DATE: 8/10/87

SUBJECT: CLUTCH RELEASE SYSTEM**VEHICLES: TURBO & 328 GTS / GTB**

**Fig. 1**

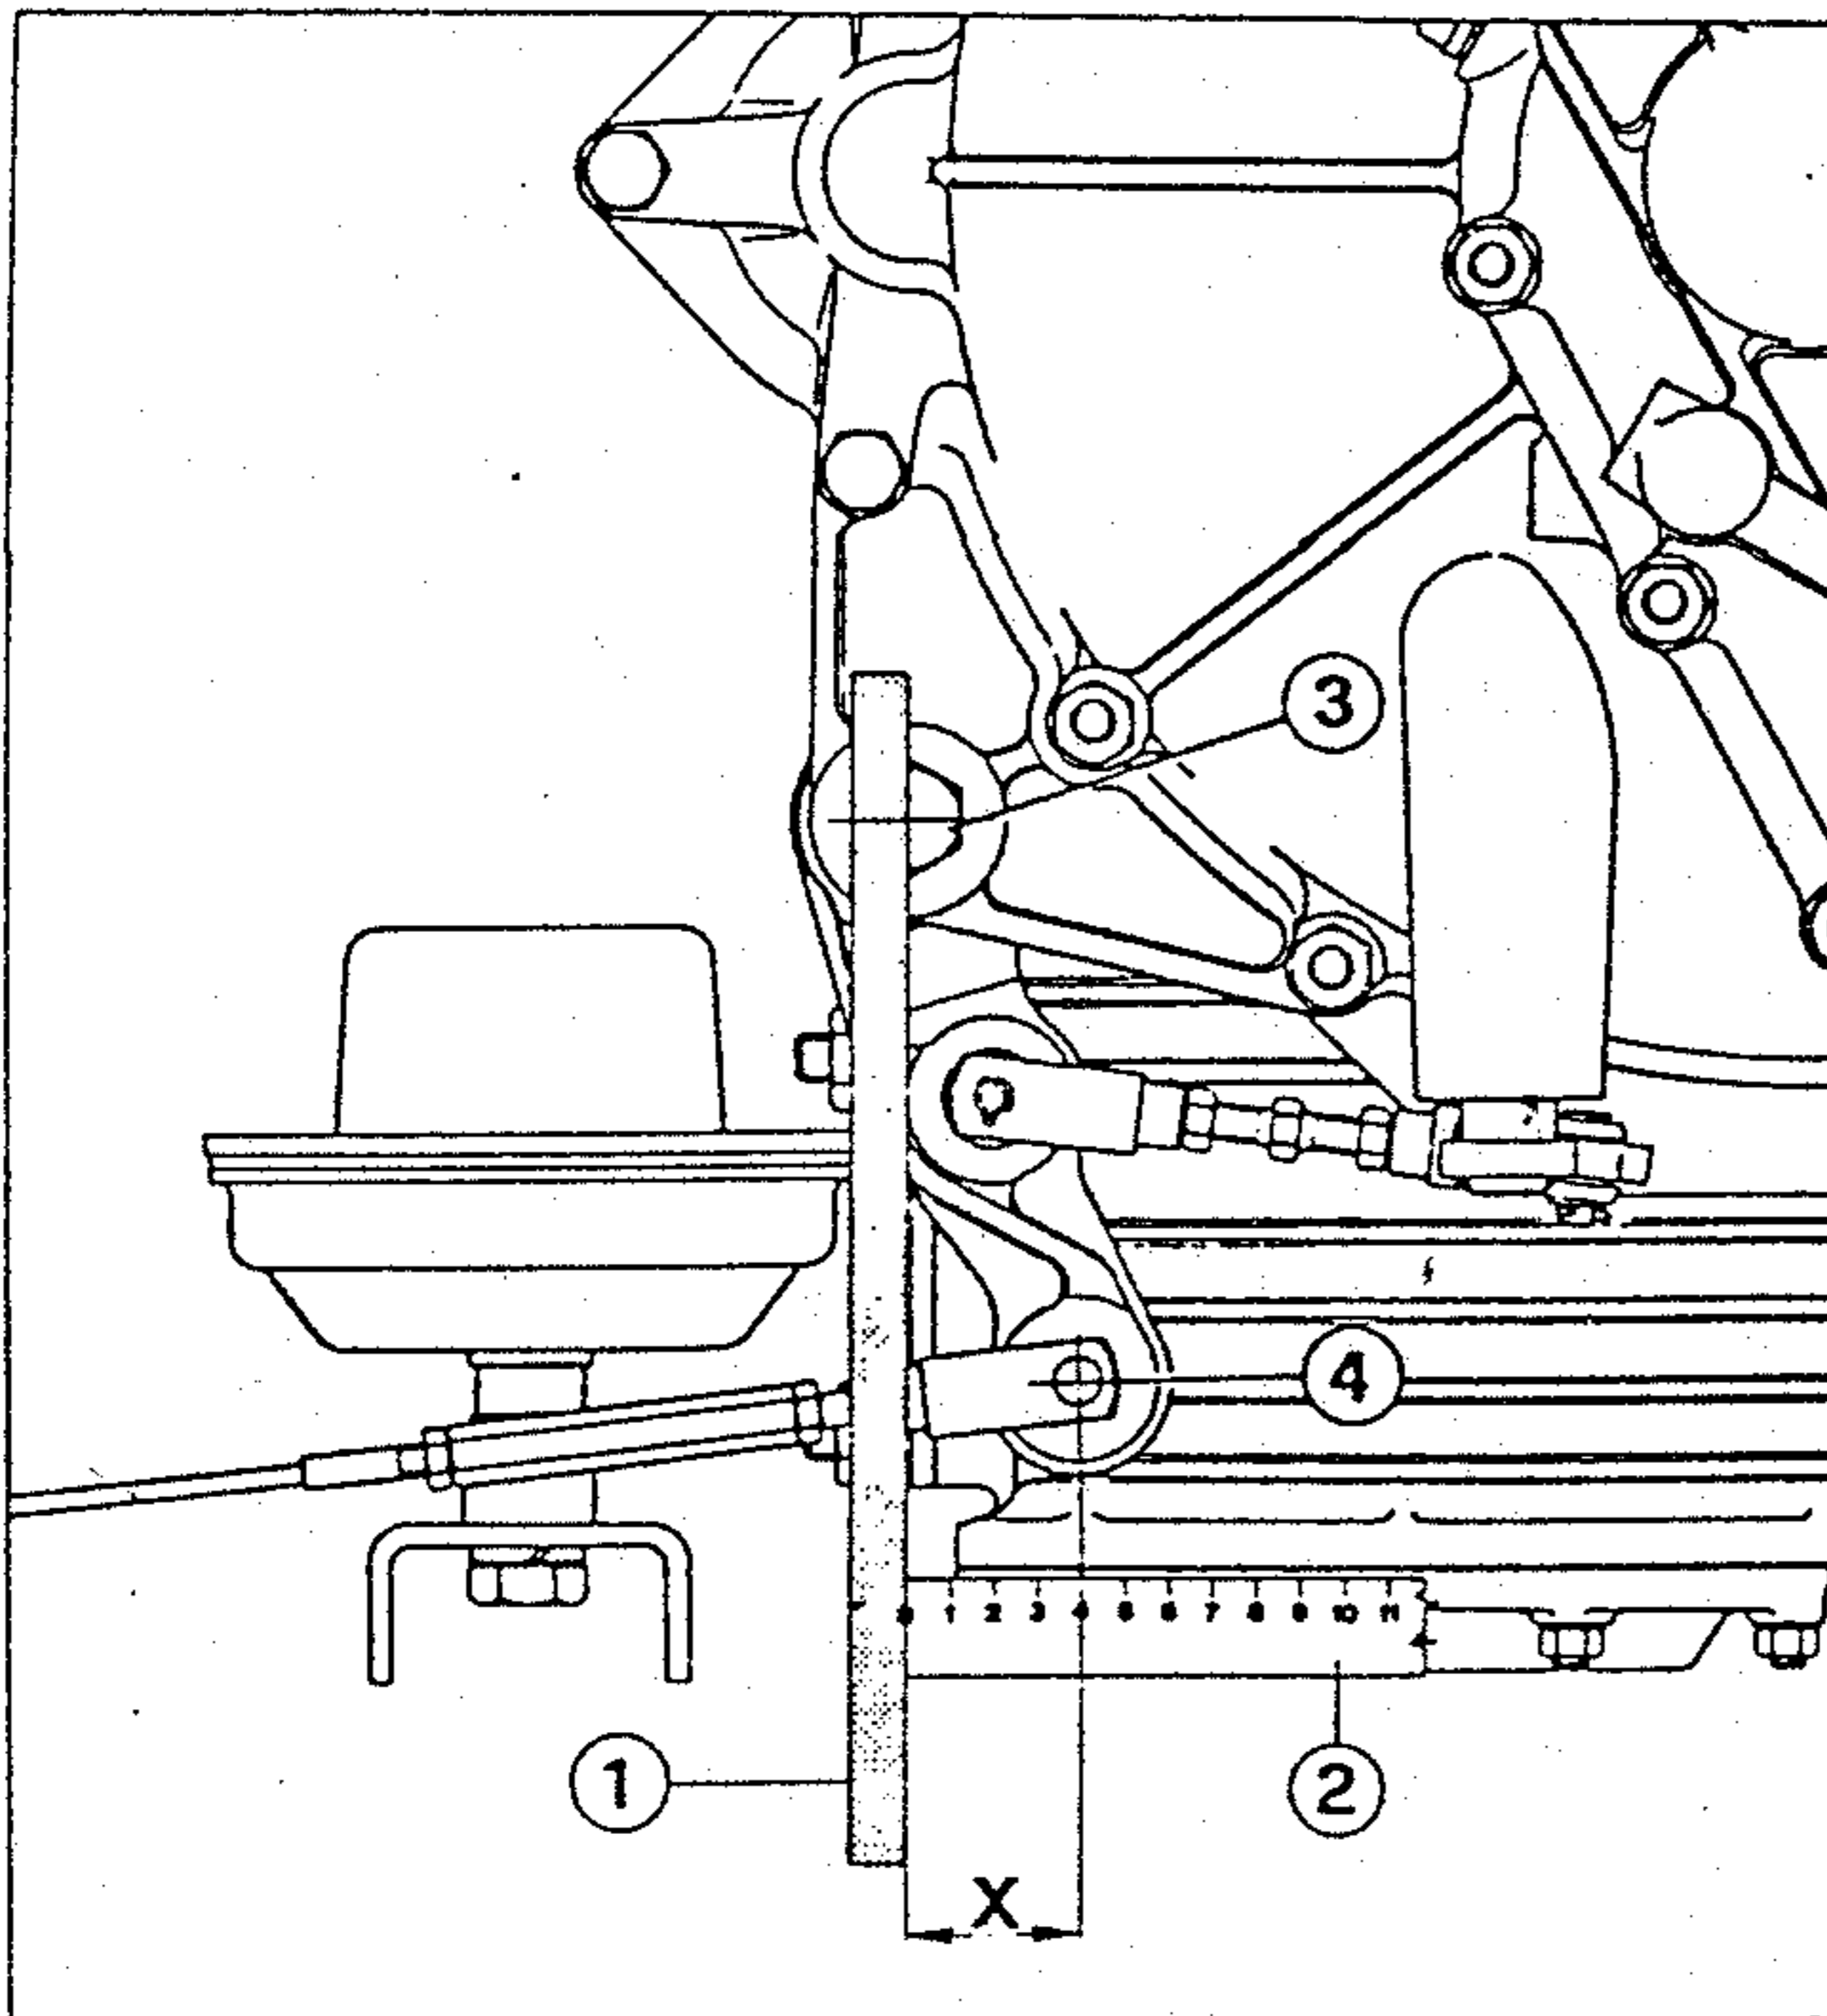
- 1 - On the clutch housing, measure the distance X (Fig. 1) with a straight edge and a ruler, as shown by Fig. 1. The distance X must read between 40 and 45 mm.

1 - Straight edge, held vertical and positioned on the center of the bolt (3).

2 - Ruler, to which the center of the pin (4) must be referred, in order to read the distance X (X= 40 to 45 mm).

Fig. 2: Clutch Control Linkage on the Clutch Housing.

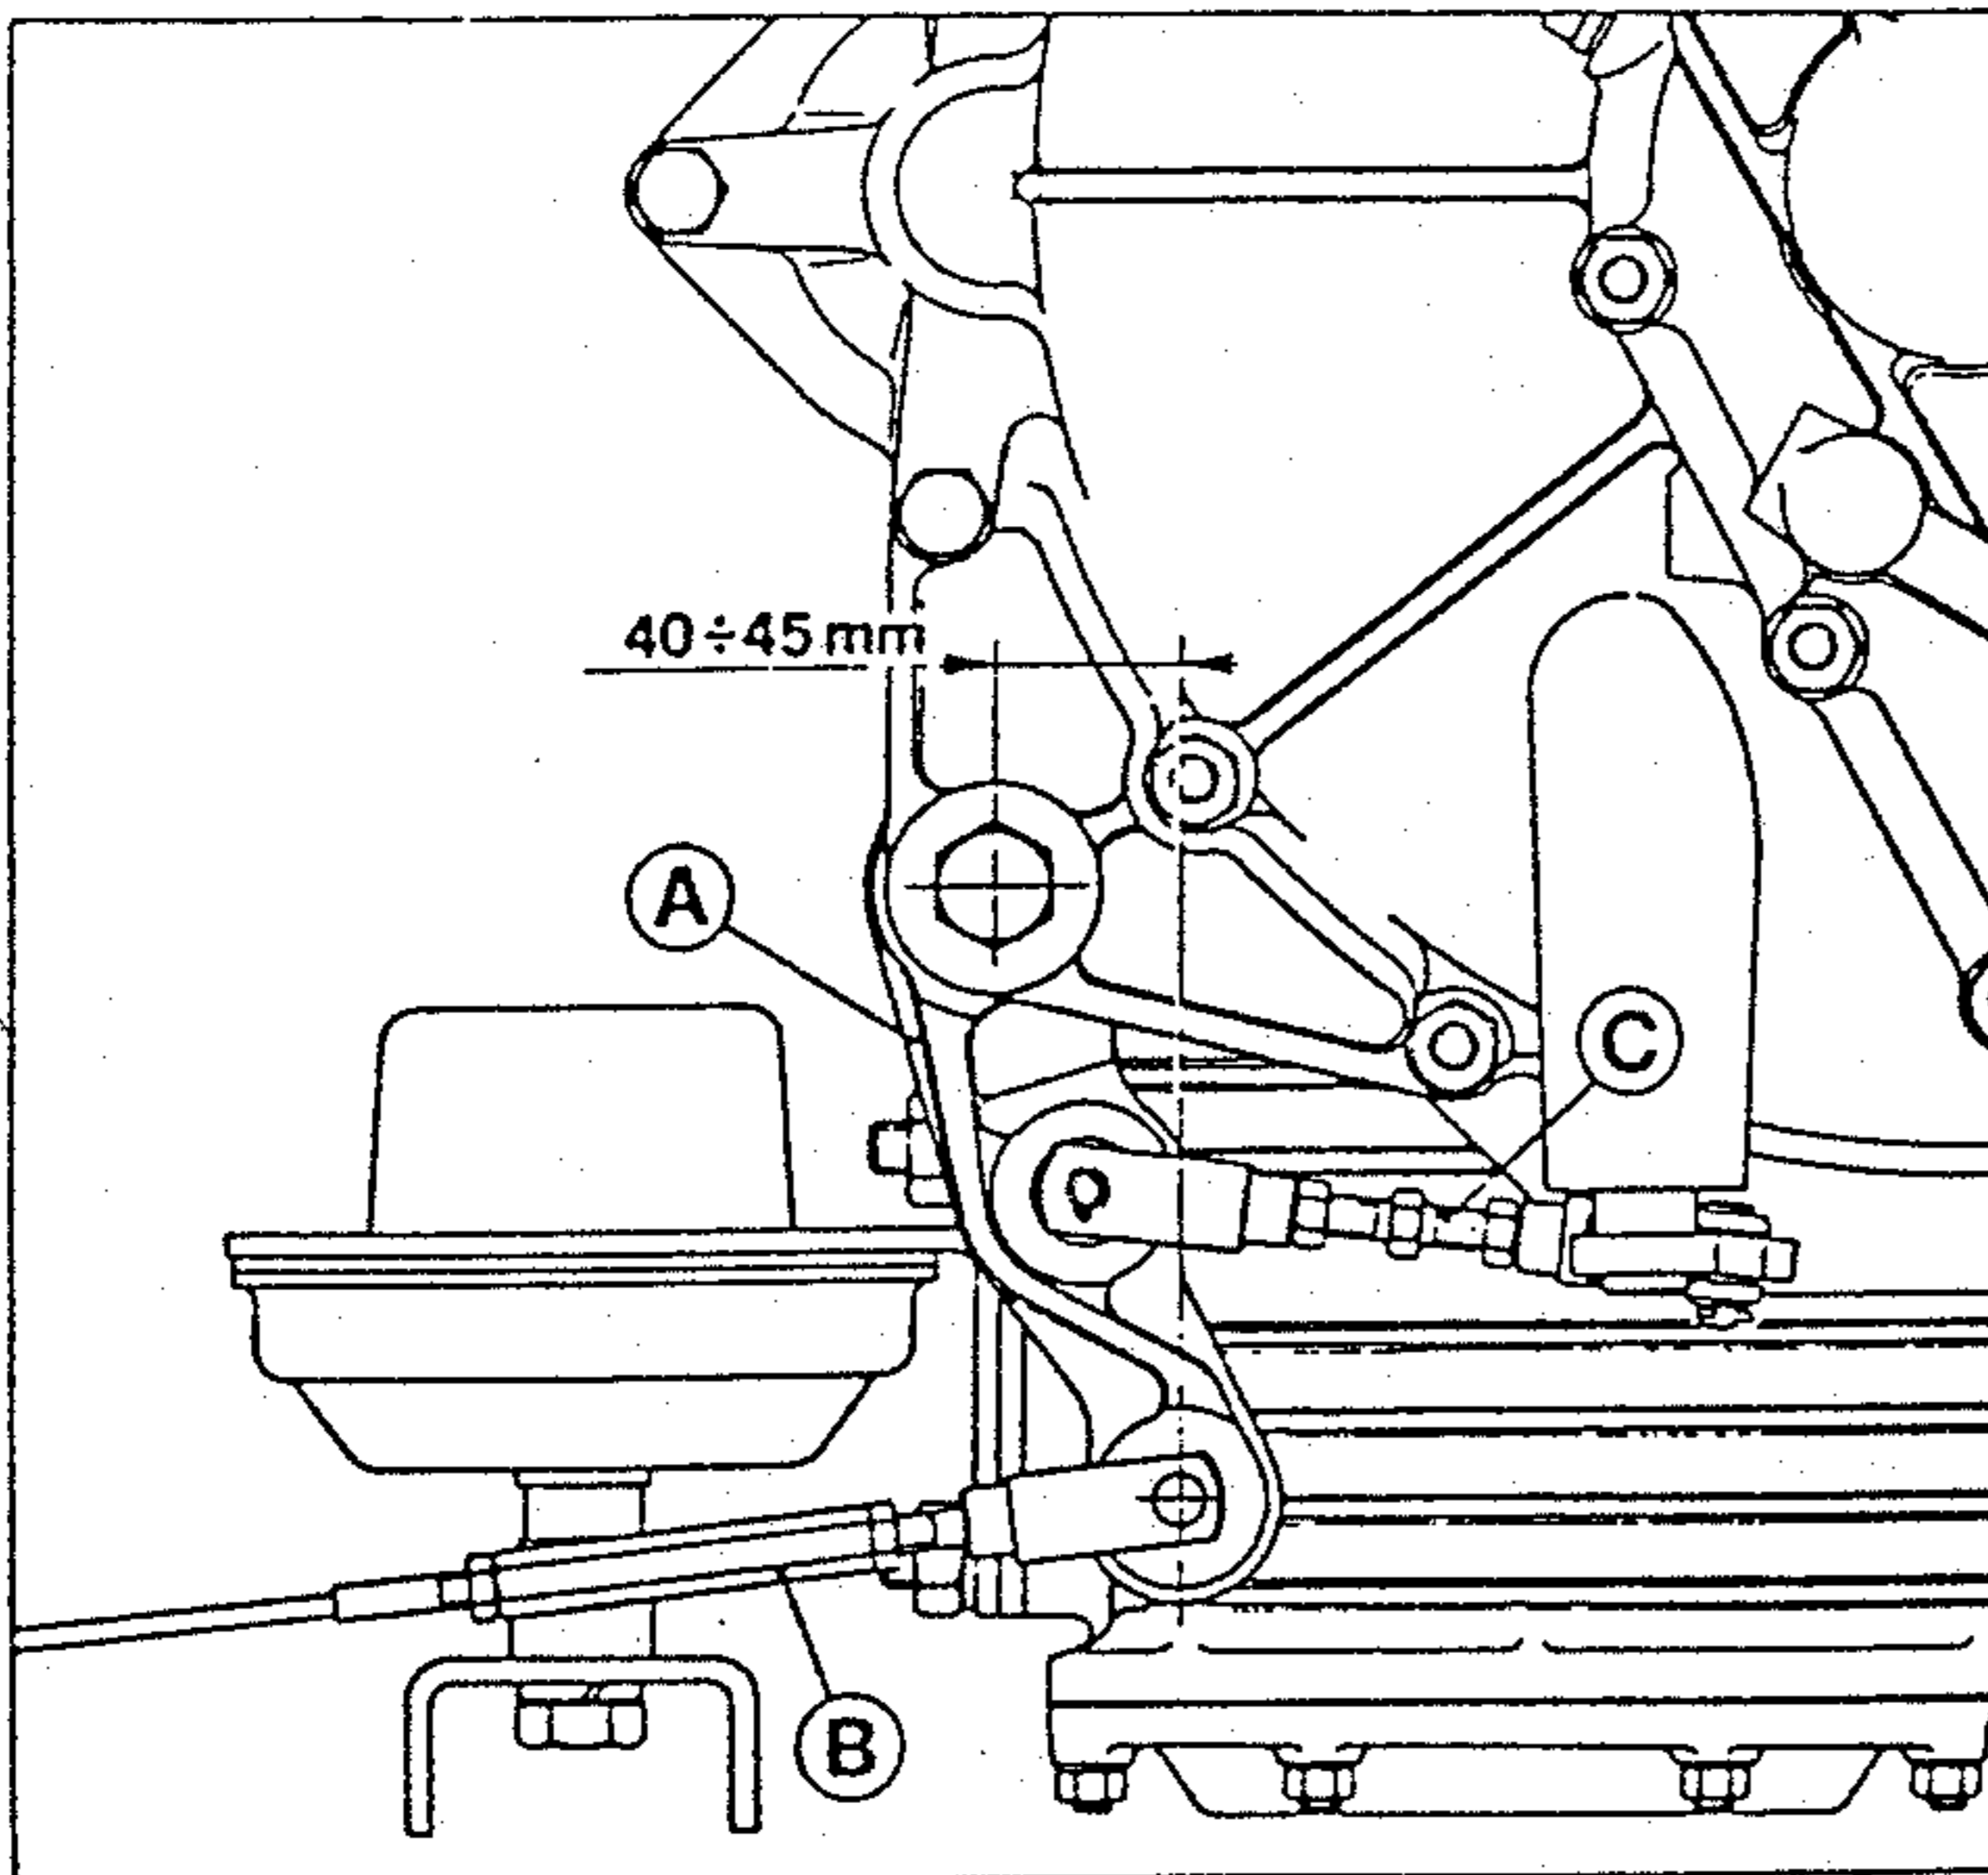
The clutch linkage positioning as shown in Figure 2 allows the release bearing and the related linkage to move backwards as the clutch disc wears normally, without any interference which would cause slipping of the clutch.

- 3 - Check the alignment of the clutch and brake pedals. If necessary, adjust only the threaded connector B (Fig. 2) in order to achieve the alignment.

- 2 - Adjust the threaded link C until the specified distance of 40 to 45 mm is achieved.
